# MAGNASTOR®

10 CFR 72.248 and  
10 CFR 72.48(d)(2)  
Partial  
24-Month Updates

**Docket No. 72-1031**

Figure 4.4-18 Three-Dimensional ANSYS Model of the BWR Canister for MTC Vacuum Drying Analyses

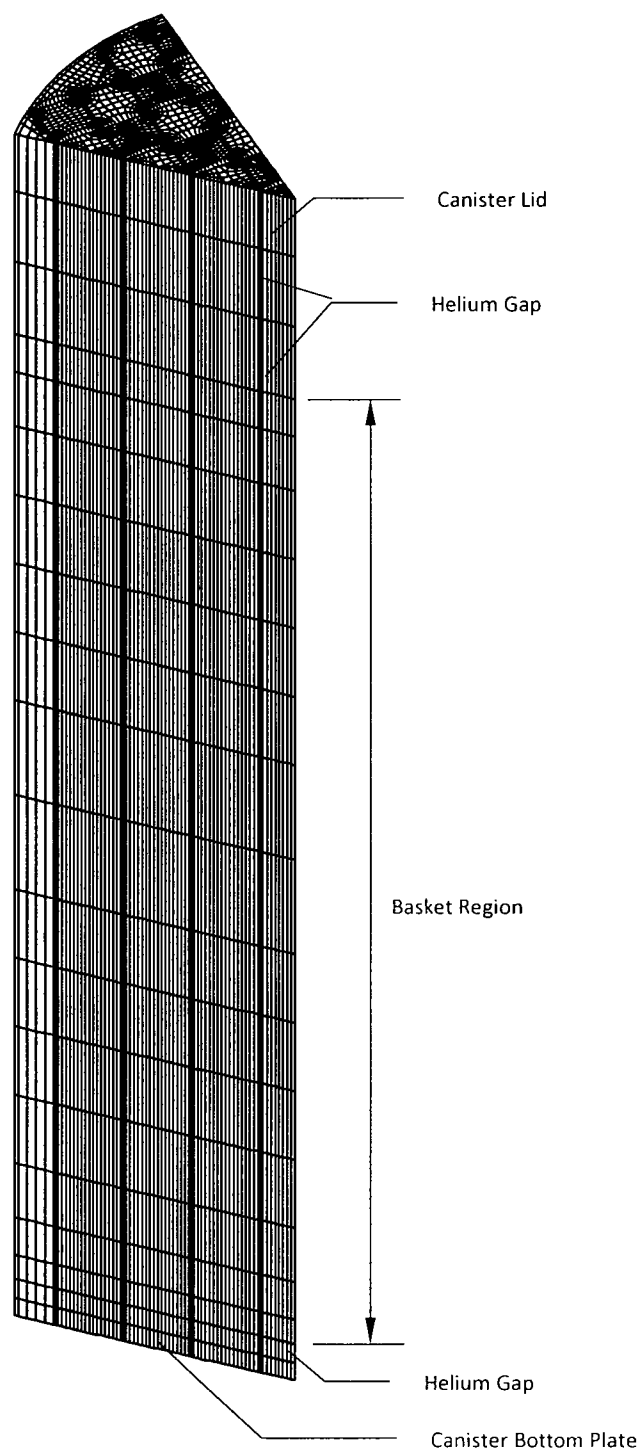
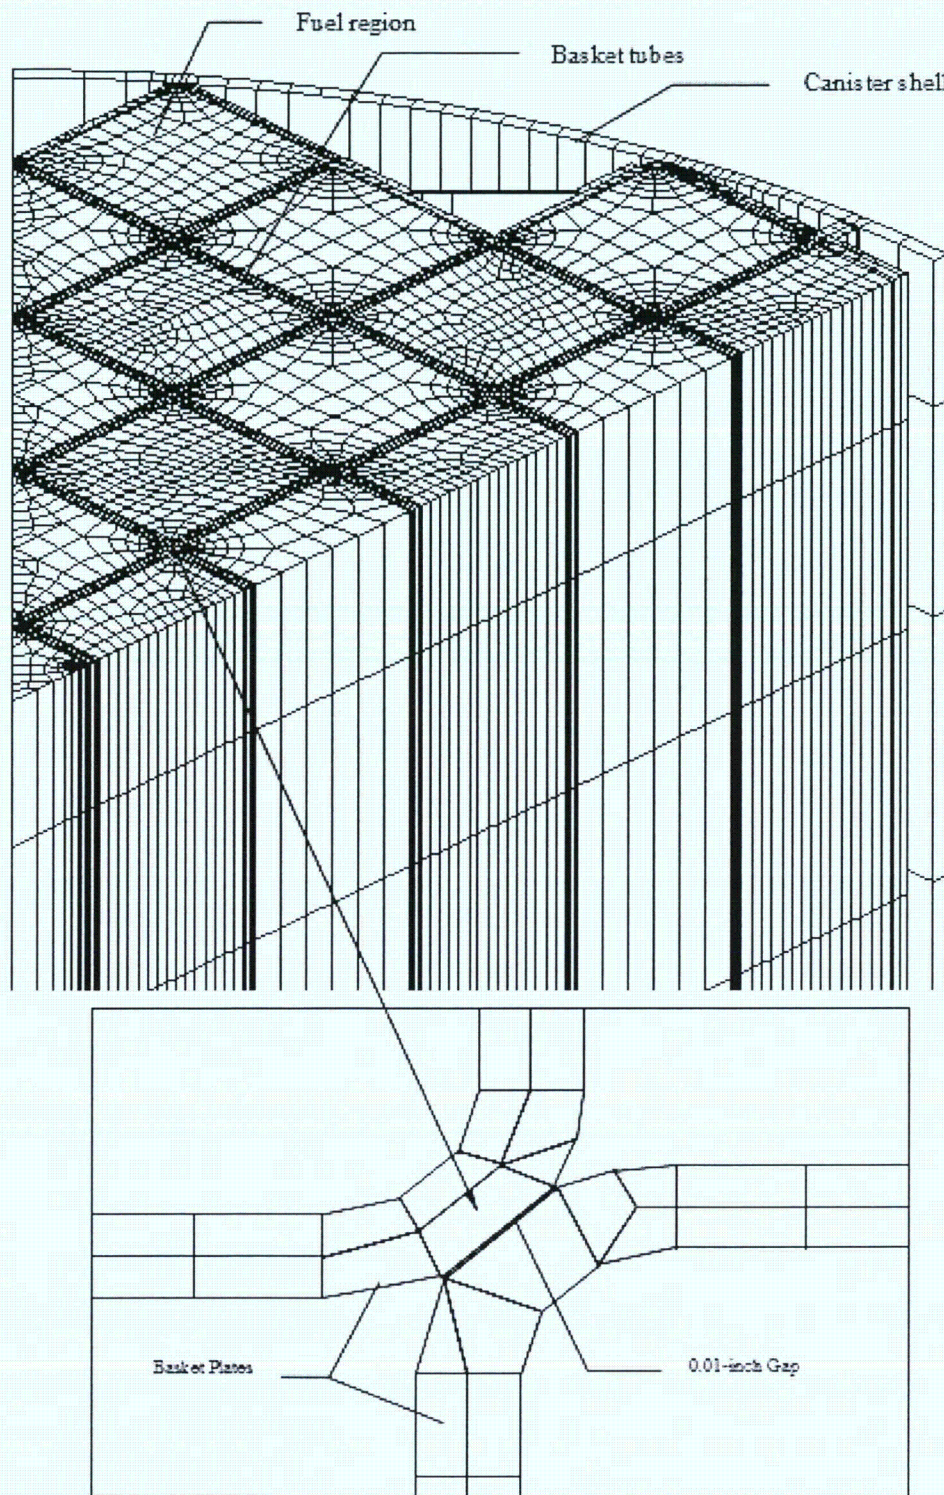
1. Revised text in the fourth paragraph on page 4.4-30.
2. Revised Figures 4.4-18 and 4.4-19 on pages 4.4-55 and 4.4-56.
3. Revised Tables 4.4-2, 4.4-3, 4.4-6, 4.4-8, 4.4-10, 4.4-12 thru 4.4-16 on pages 4.4-60 thru 4.4-68.
4. Revised the last embedded table on page 4.5-2.
5. Revised the embedded table on page 4.6-1.
6. Revised Table 8.3-27 on page 8.3-15.
7. Revised the embedded table on page 10.1-14.
